CITY OF ALBUQUERQUE

Re: Panda Express Restaurant

Albuquerque, NM 87107 Traffic Circulation Layout

Engineer's Stamp 9/11/25 (H16D083F5) TRANS-2025-00278

SITE PLAN

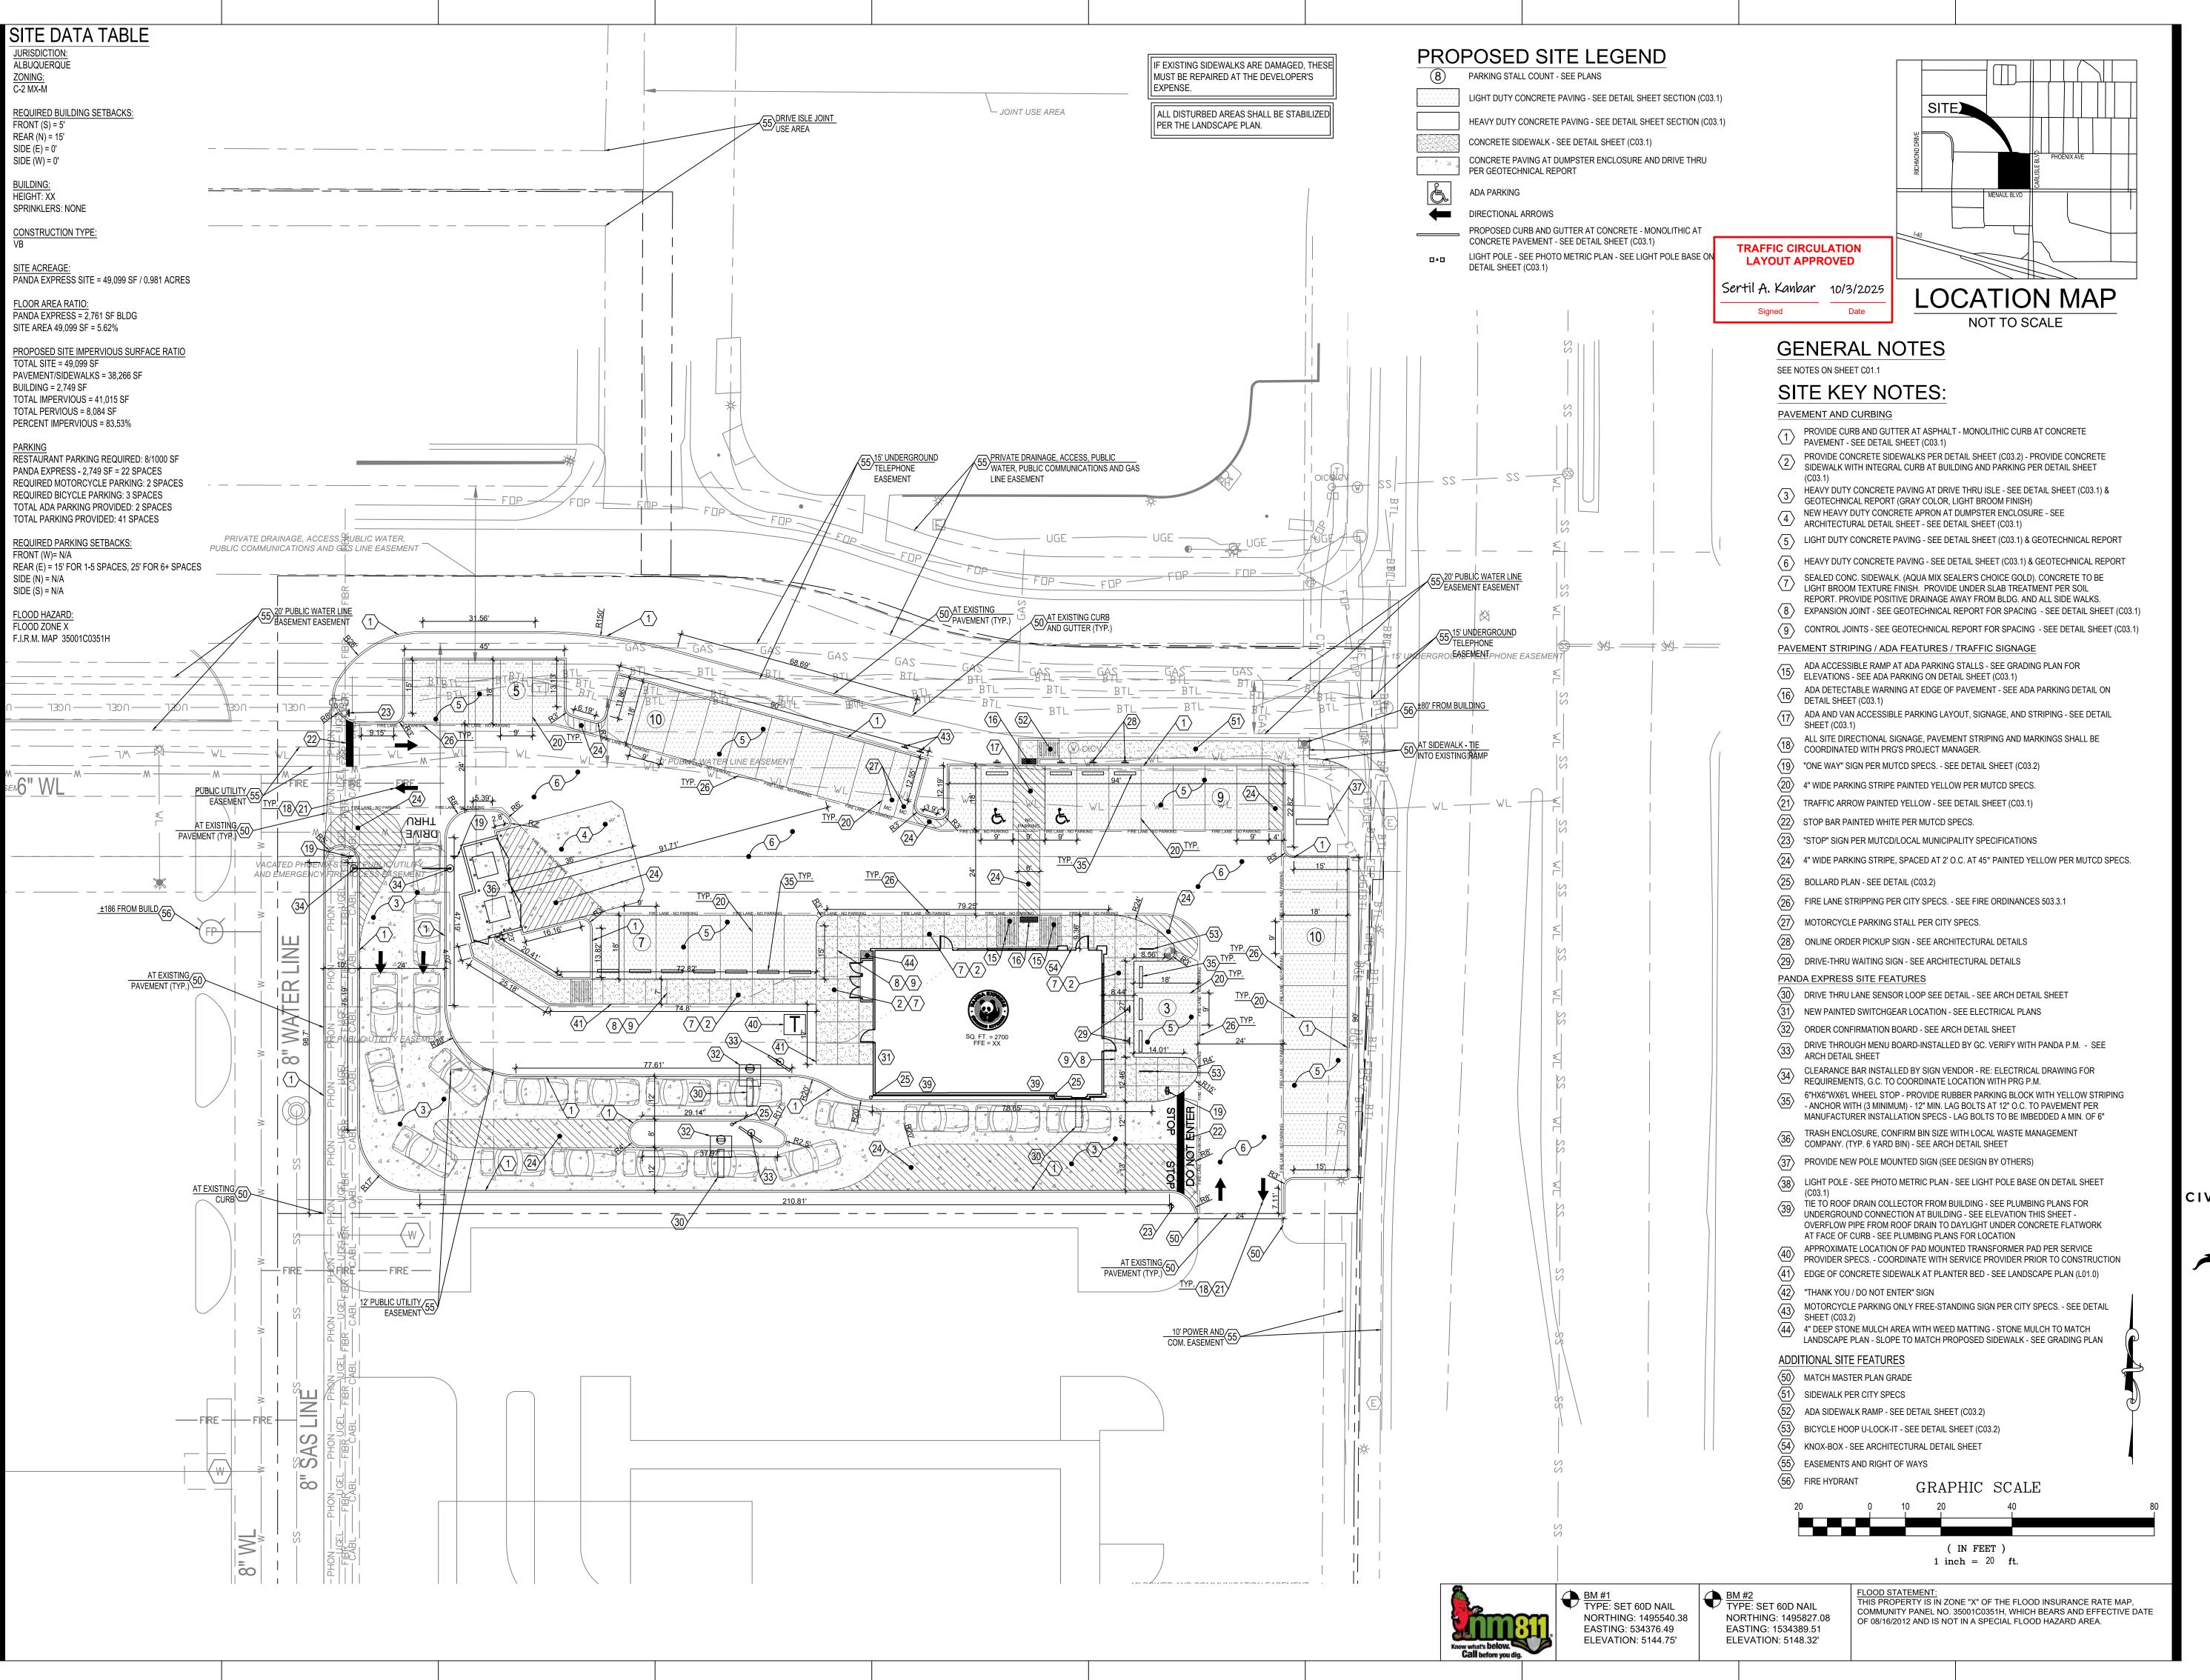
The TCL submittal received 9-26-25 is approved for Building Permit by Transportation. A copy of the stamped and signed plan will be needed for each of the building permit plans. Please keep the original to be used for certification of the site for final C.O. for Transportation.
